ADDENDUM NO. 4

RFQ CCC-056

**New Student Services Building
Compton Community College District**

tBP Project. No. 20987.00

drawing no.:
S0-1.8
drawing of

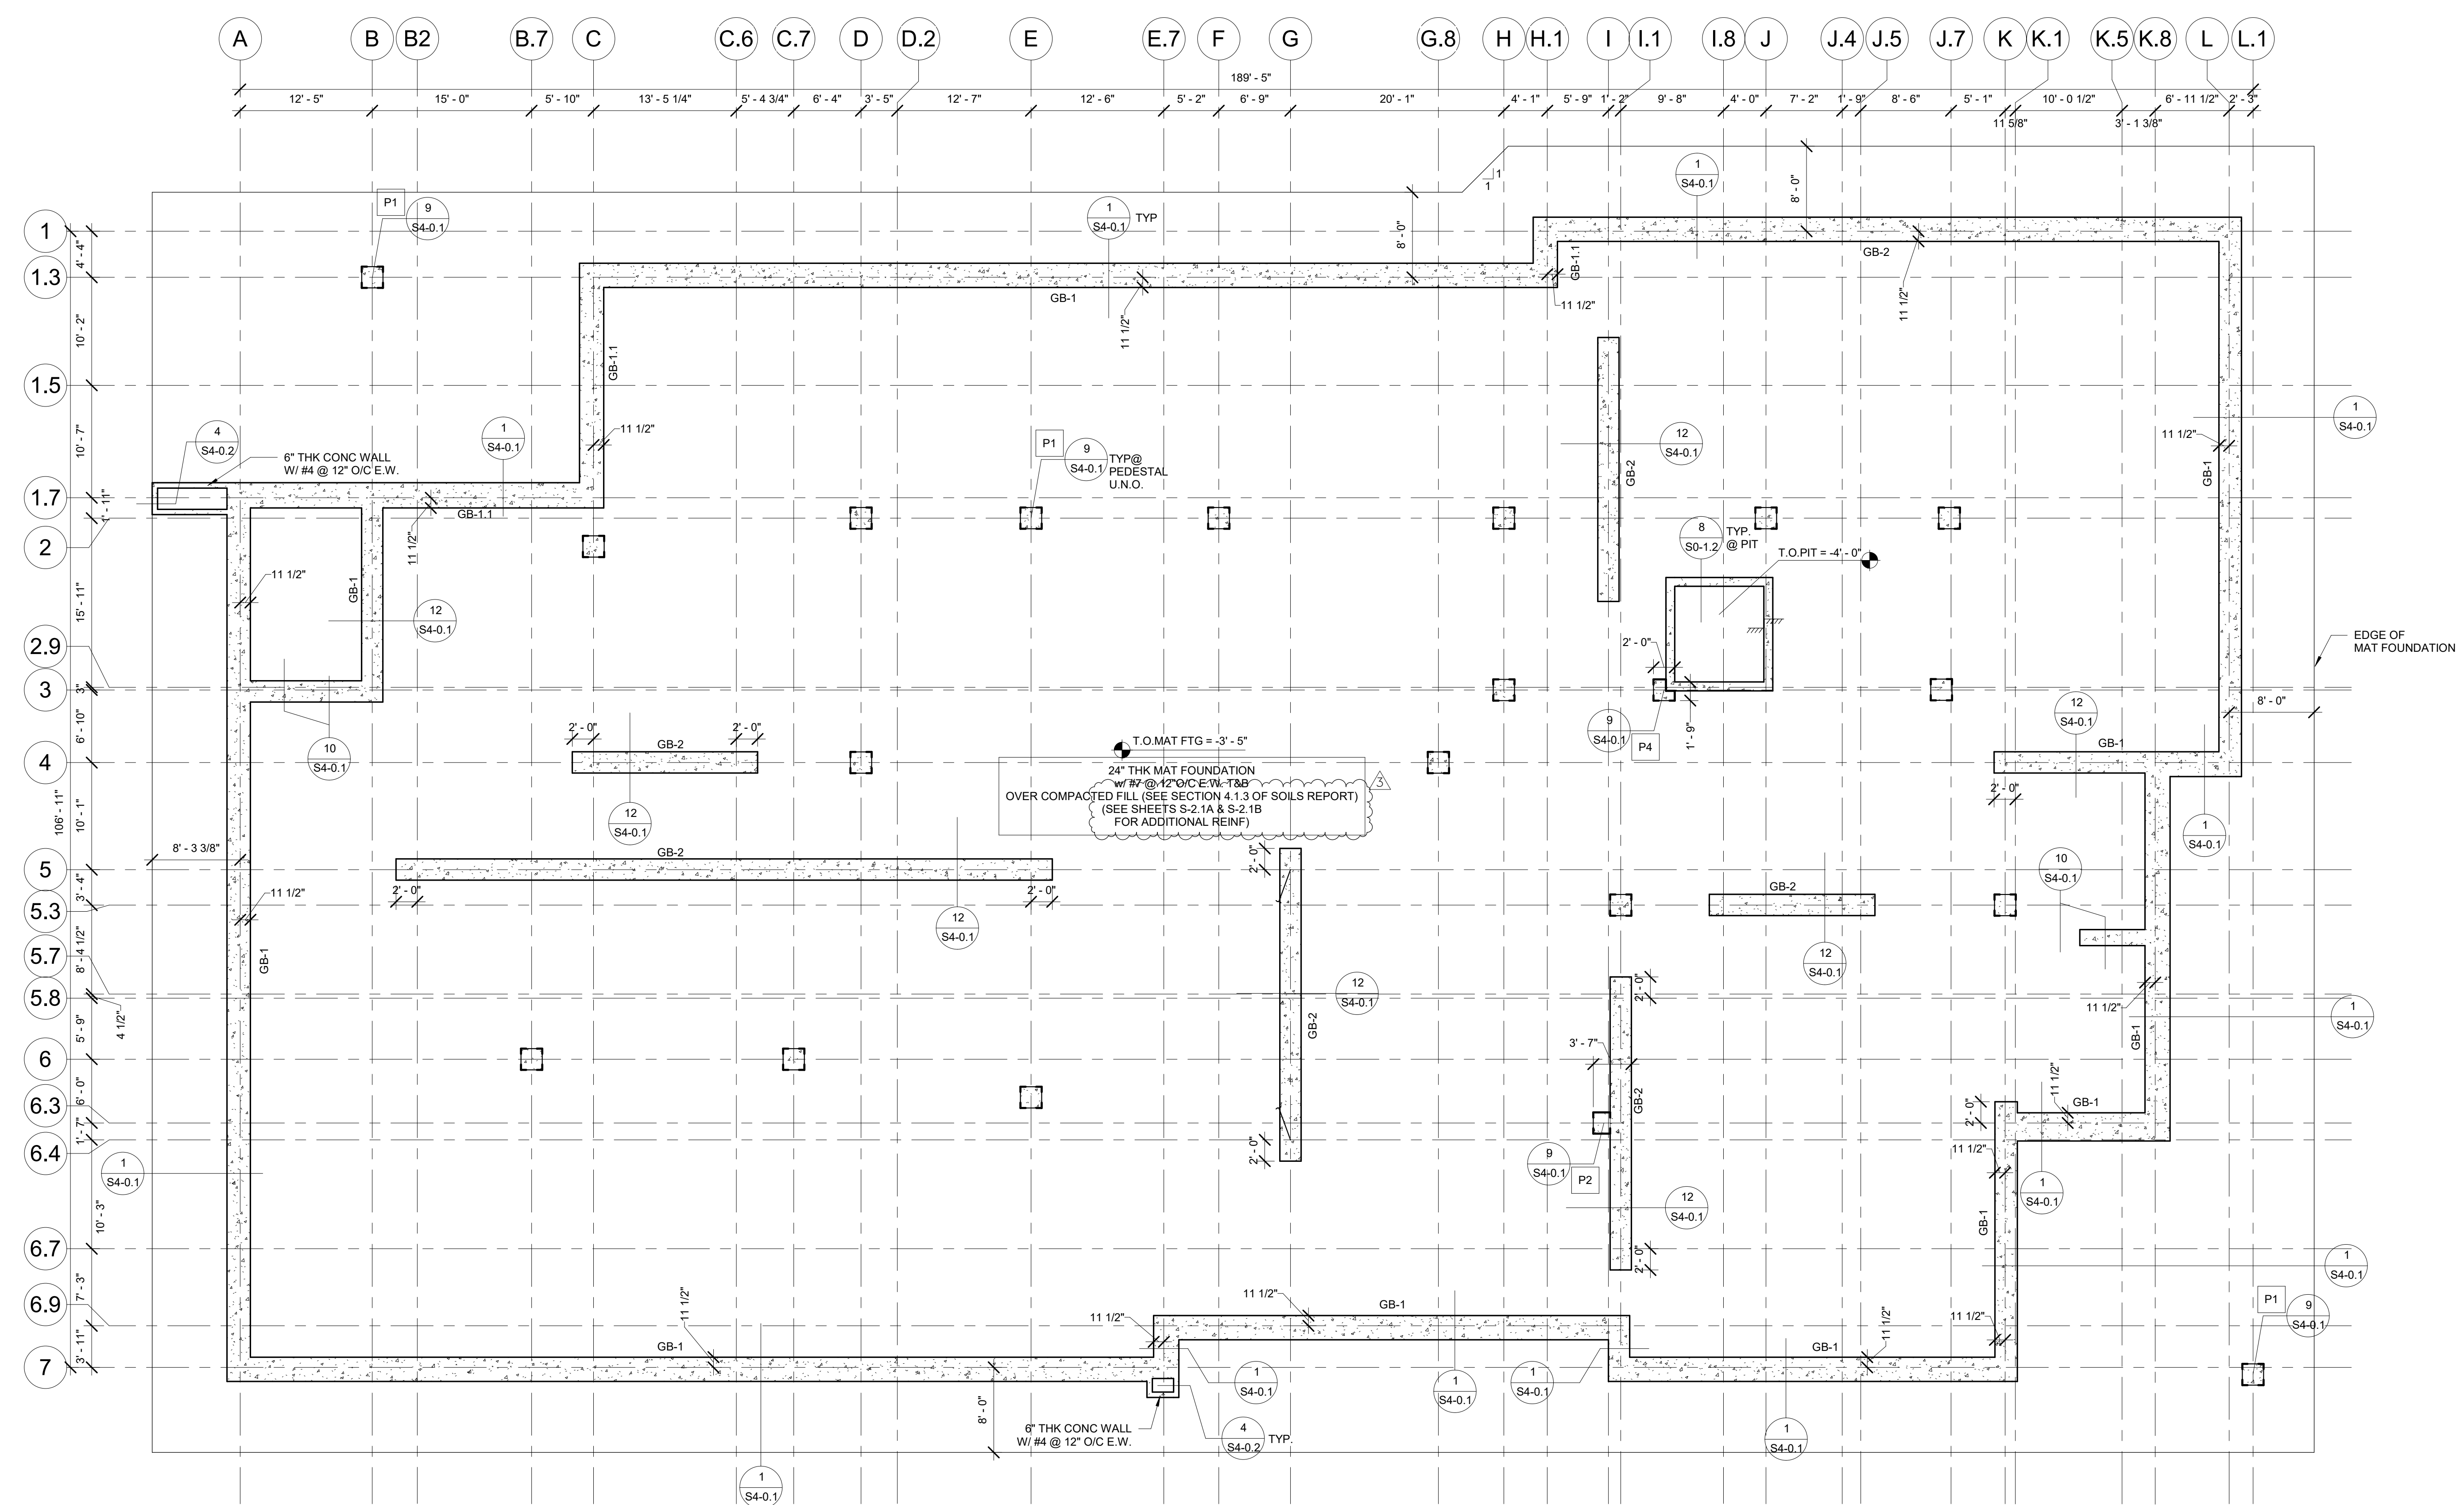
16. Revised SHEET S0-1.8 TYPICAL DETAILS

- a. Detail 9: Added 9ft. max. angle length.
17. Revised SHEET S-2.1 MAT FOUNDATION PLAN
- a. Reference added on sheet S-2.1A and S-2.1B for additional reinforcement.

drawing no.:
S-2.1
drawing of

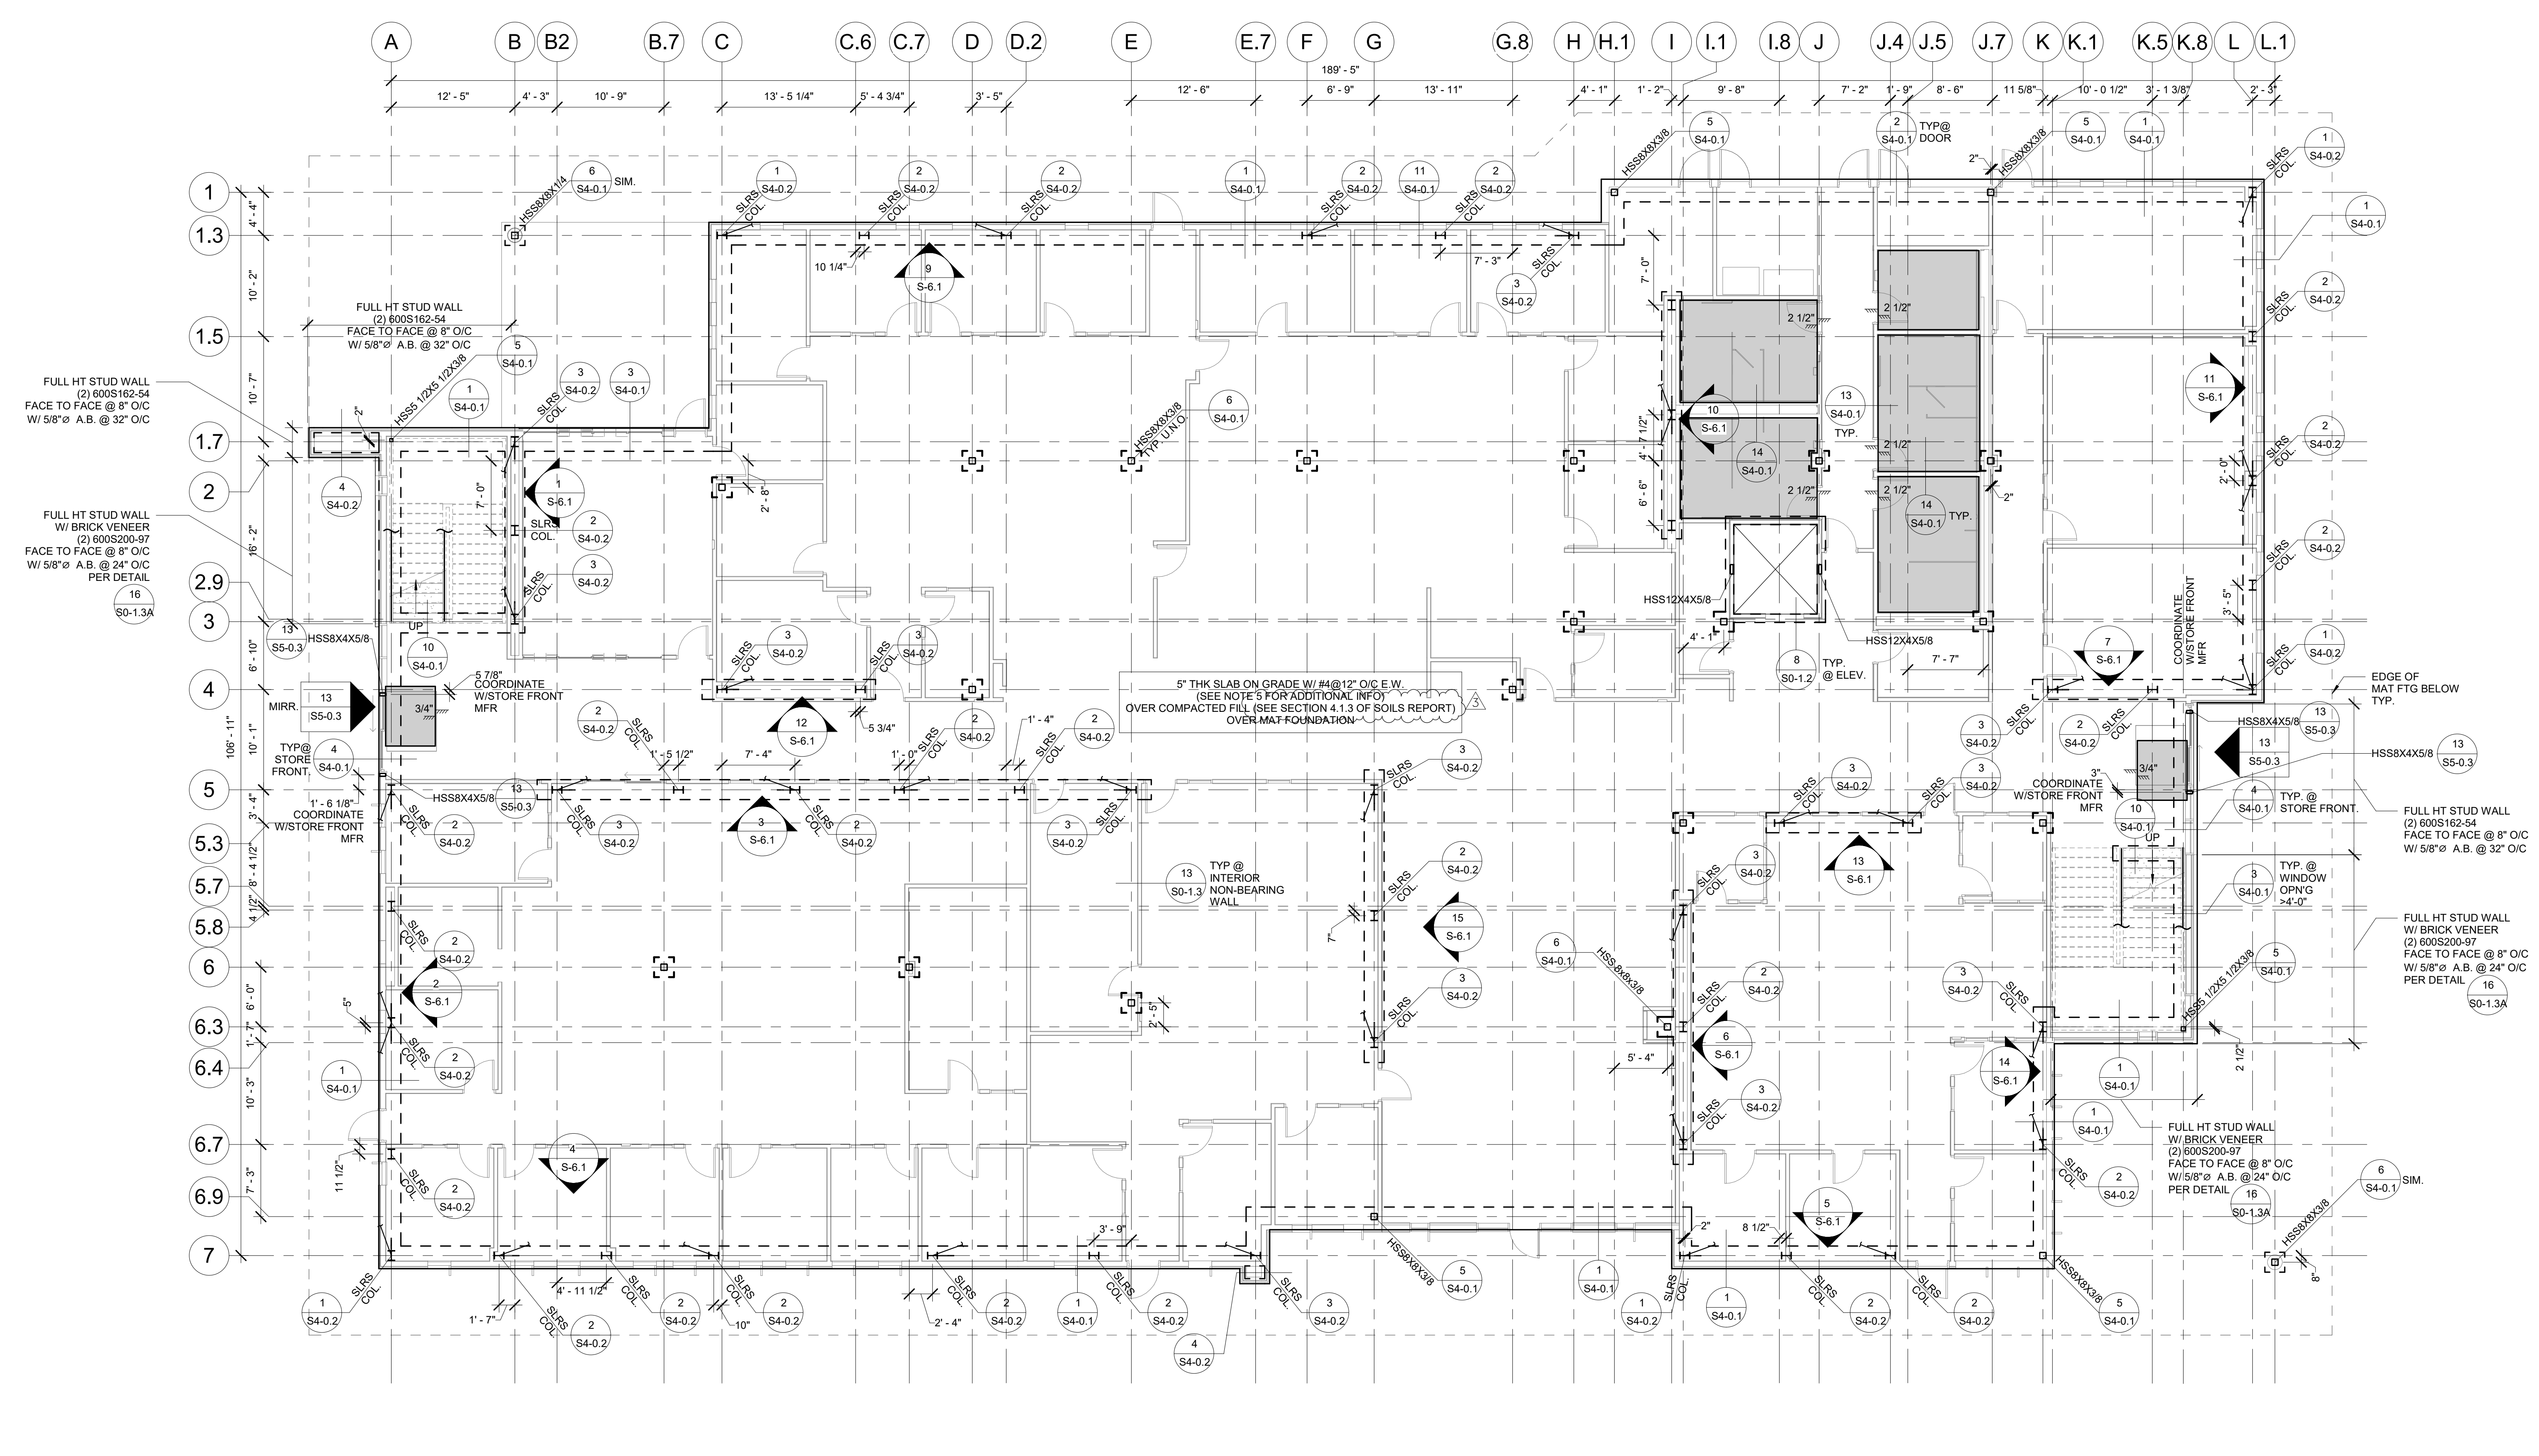
- b. Added reference to soils report for fill compaction requirements.
18. Revised SHEET S-2.2 GROUND FLOOR SLAB PLAN
- a. Added reference to soils report for fill compaction requirements.

drawing no.:
S-3.1
drawing of

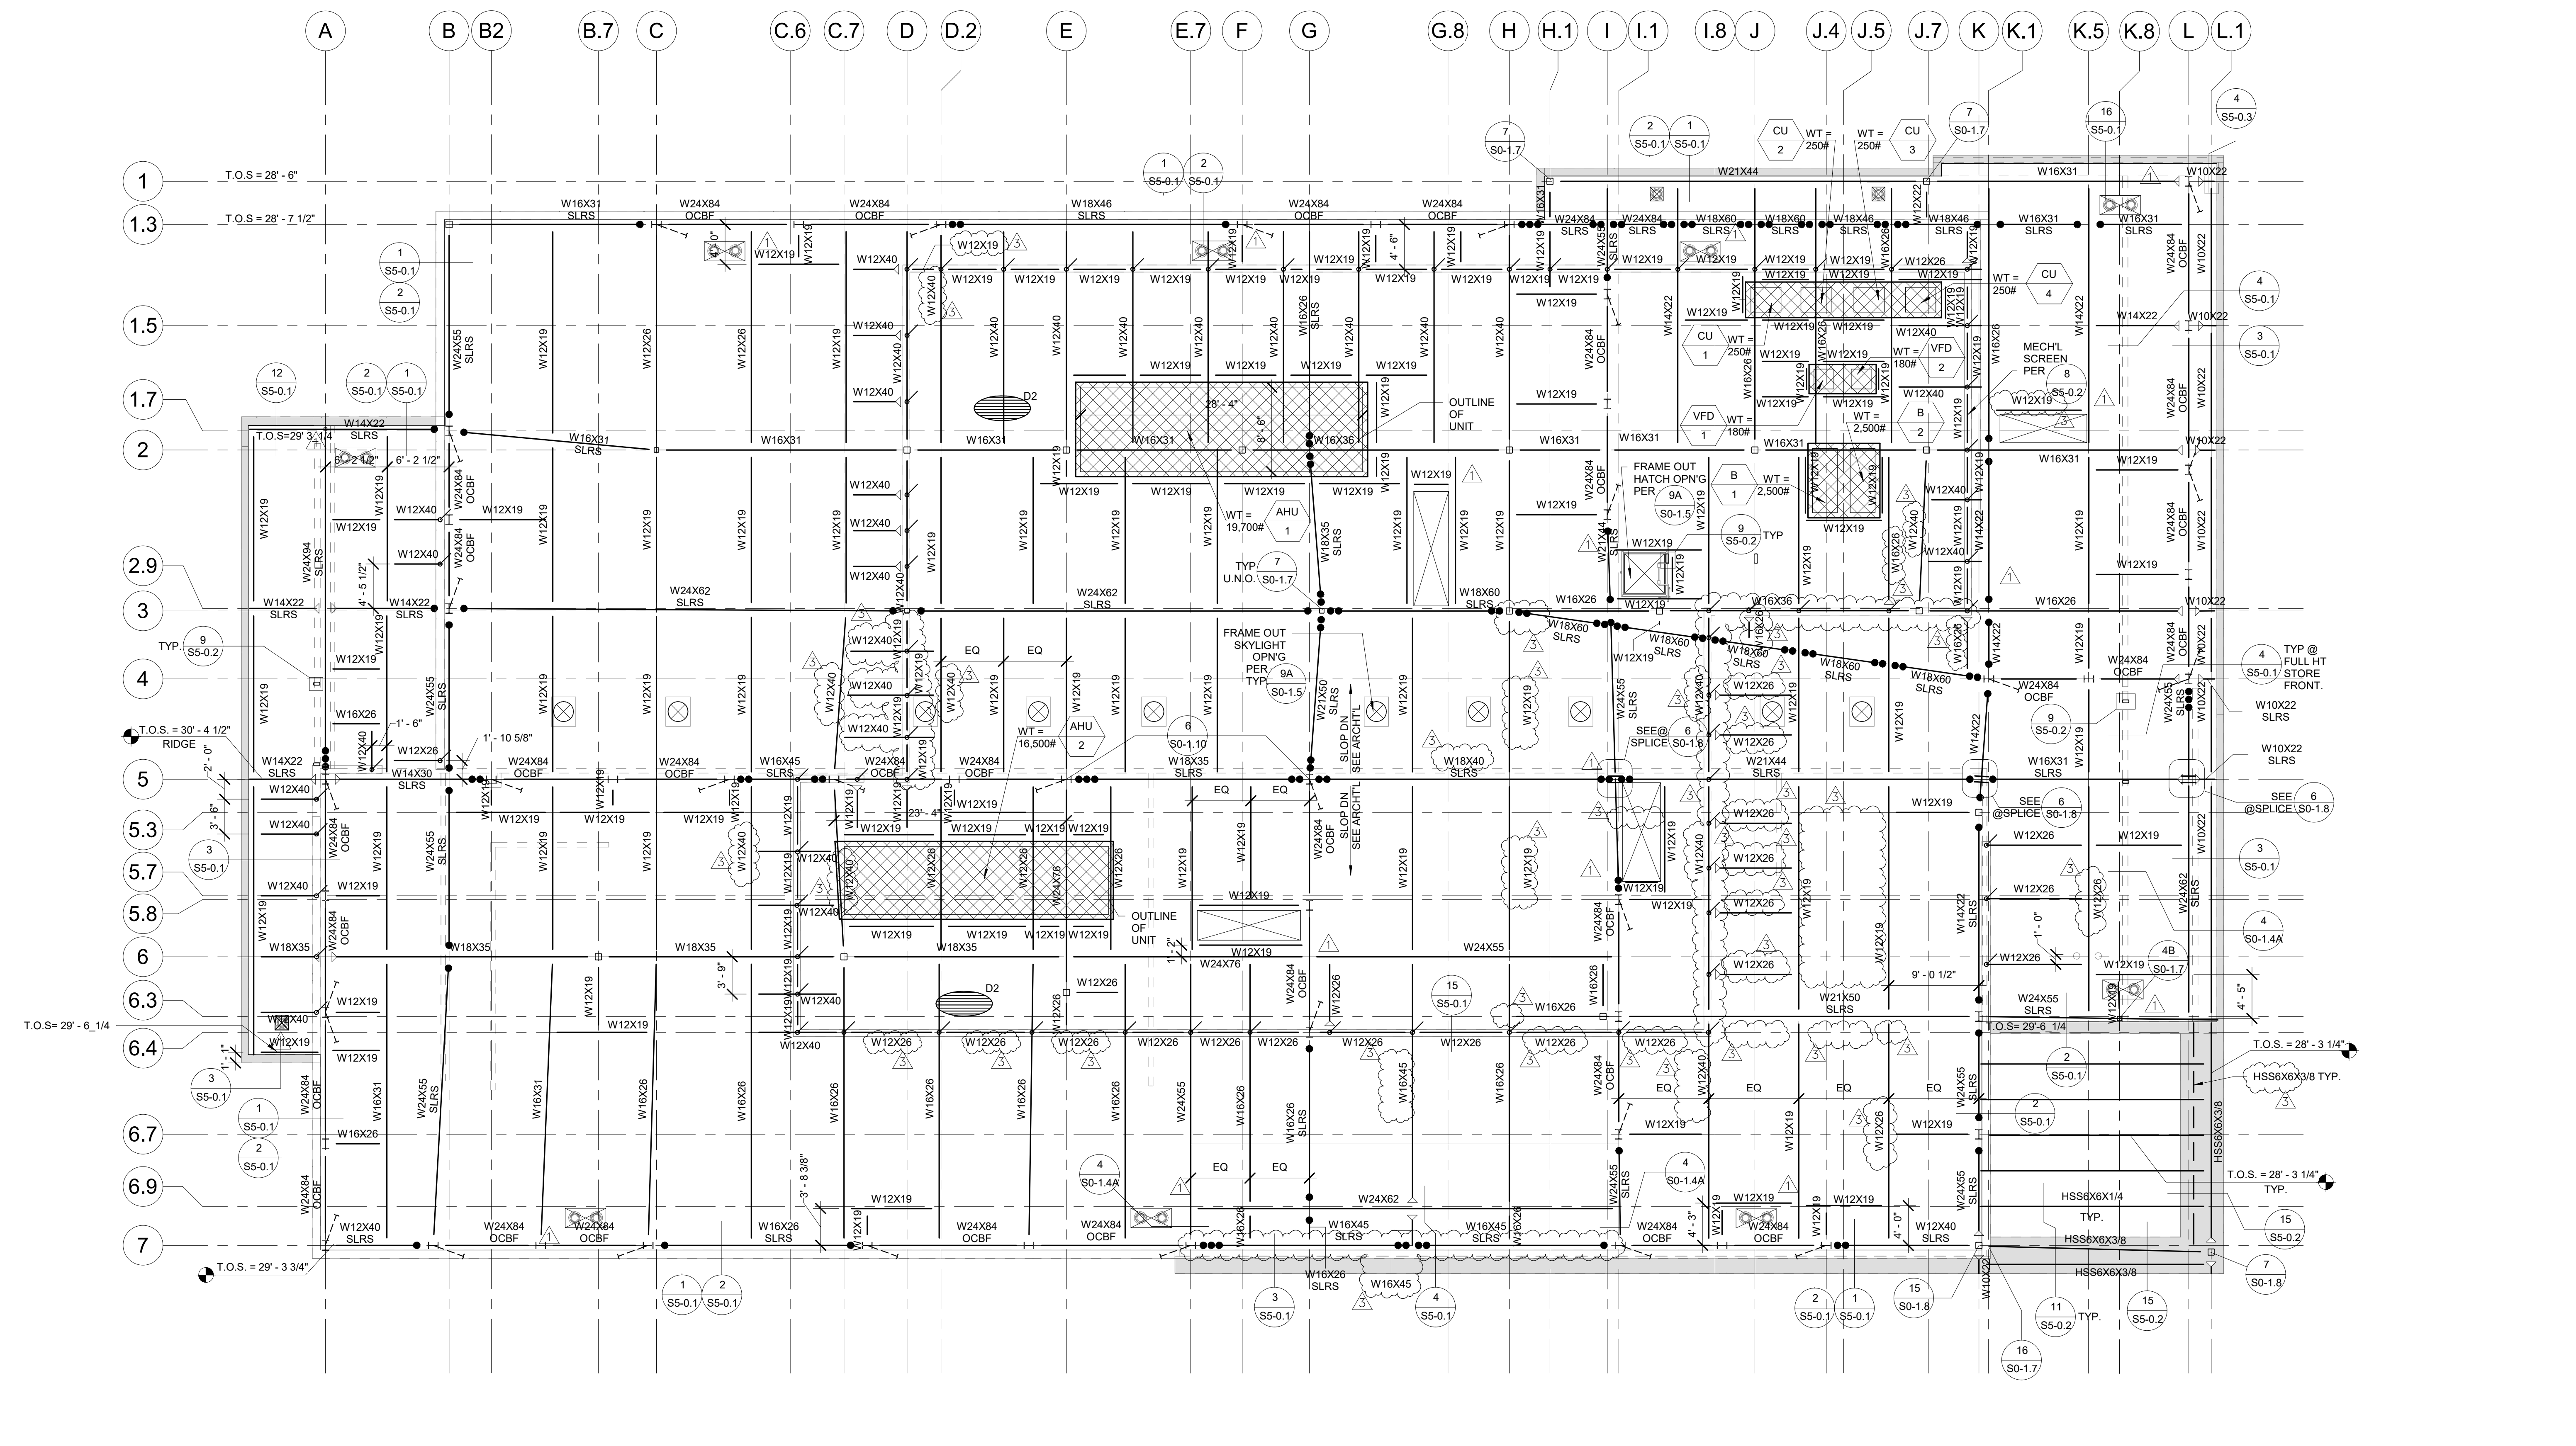
19. Revised SHEET S-3.1 SECOND FLOOR FRAMING PLAN
- a. Showing W12x at end of bridge at seismic gap.
 - b. Framed out opening for shaft near waiting room 230A.

- c. Added sheet note 14 to clarify bracing at SLRS.
20. Revised SHEET S-3.2 ROOF FRAMING PLAN
- a. Updated select framing members
 - b. Updated HSS trellis support beam
